HERITAGE PRESERVATION COMMISSION REPORT
Certificate of Appropriateness
Section 20-92

PROPOSAL: The applicant is proposing to make several exterior repair and restorations to the exterior of the building located at 721 King Street. (First Methodist Episcopal Church))

P6 CORNICE DETERIORATION
NO SCALE

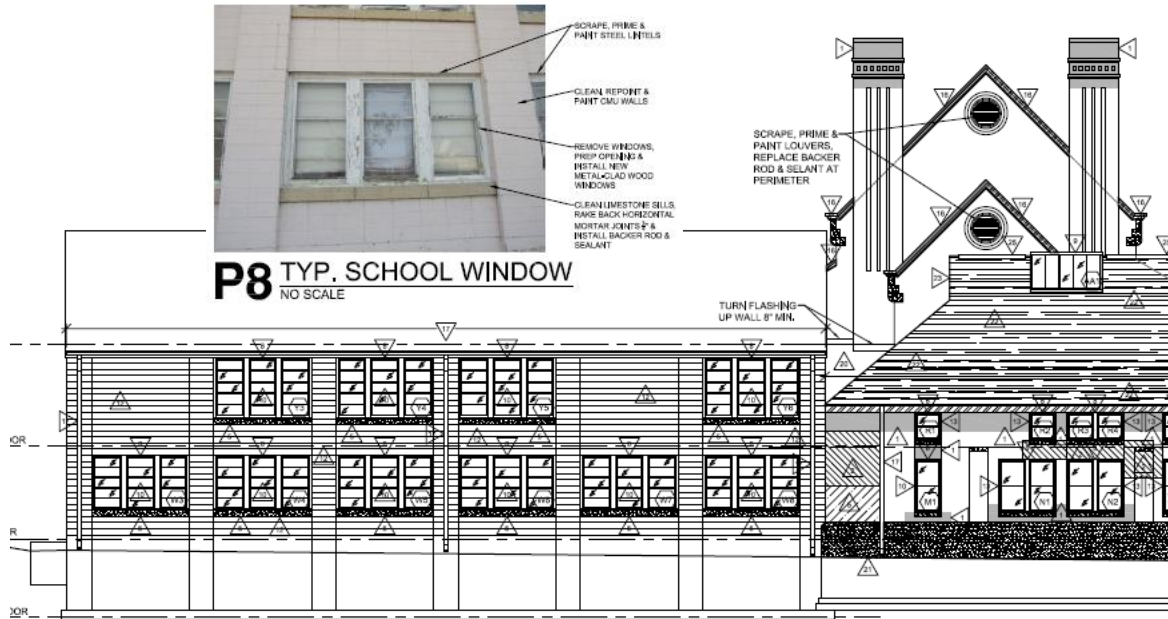
- CHECK ALL FLASHINGS, REPLACE DETERIORATED PIECES, REATTACH & RESEAL LOOSE PIECES
- SCRAPE, PRIME & PAINT METAL CORNICE, FABRICATE NEW LINER IN METAL, GUTTERS & INSTALL HEAT TRACE CABLE, REPLACE SEVERELY DETERIORATED PIECES IN-WORD
- REPORT DETERIORATED MORTAR JOINTS WITH TYPE 'O' MORTAR, REPLACE SPALLED BRICK IN-WORD
